UNITED STATES PATENT AND TRADEMARK OFFICE

APPLICATION NO.	FILING DATE	FIRST NAMED INVENTOR	ATTORNEY DOCKET NO.	CONFIRMATION NO.
10/511,070	10/12/2004	Steven Victor Jones		8765
7590	04/30/2007		EXAMINER	
The Black & Decker Corporation Mail Stop TW199 Towson, MD 21286			MITCHELL, KATHERINE W	
		ART UNIT	PAPER NUMBER	
			3677	
MAIL DATE	DELIVERY MODE			
04/30/2007	PAPER

DETAILED ACTION

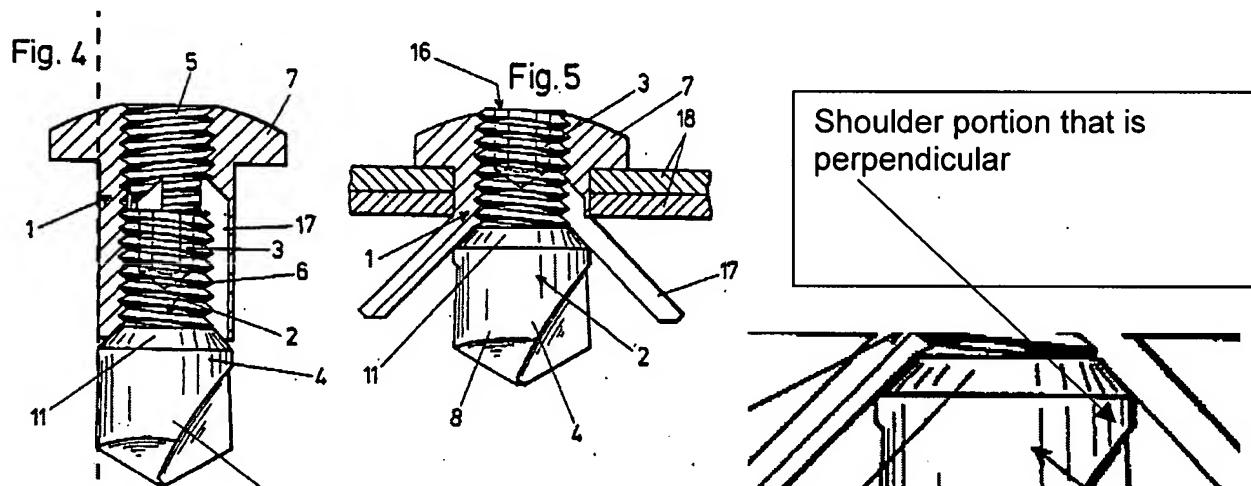
RE claims 1,12 and 19: Palm teaches a peel type blind rivet with an elongate tubular body 1 having a shank (Fig 1 and 4) and preformed head 7 and expandable portion (end including 12 and 17) at end opposite head. The expandable portion comprises a bore which is a constant inner diameter (Figures copied below), and an external surface with a constant outer diameter and the body defines a plurality of slots 12 (Column 5 lines 27-61) which terminate remote from said first end. The mandrel has a stem extending co-axial through said tubular body, with a mandrel head unit 4 with maximum external diameter larger than the body internal diameter, and the mandrel head has a shoulder portion in contact with the opposed end defining a bearing surface (Fig 4) which is ***substantially*** perpendicular to the stem.

Further regarding claim 12 and 19: The detail above shows a perpendicular shoulder portion - it is inherently in contact with the opposed end when the mandrel is 1st pulled thru the opposite end.

Re claim 9: The embodiment of Figs 1-3 shows a breakneck or reduced diameter portion, 10. Note that in Fig 4, the shoulder is the slightly enlarged area as shown in the detail above, and in this case, the reduced diameter portion is portion 11.

Re claim 10: The max diameter of the mandrel head is equal to the external diameter of shank, see examiner's dotted line in Fig 4 above and Fig 1 below..

FIG.12

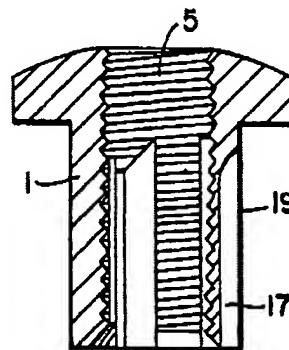
Re claims 3-6, 14-17: The slots are shown as described in Figs 12-15, noting that column 5 lines 27-61 states the grooves 17 can be through slots.

Palm shows slots 12/17 extending in a width from an outer surface to an inner surface of said tubular body in Fig 12 and col 5 lines 26-61, and further teaches in Palm col 5 that the sidewalls can be curved:
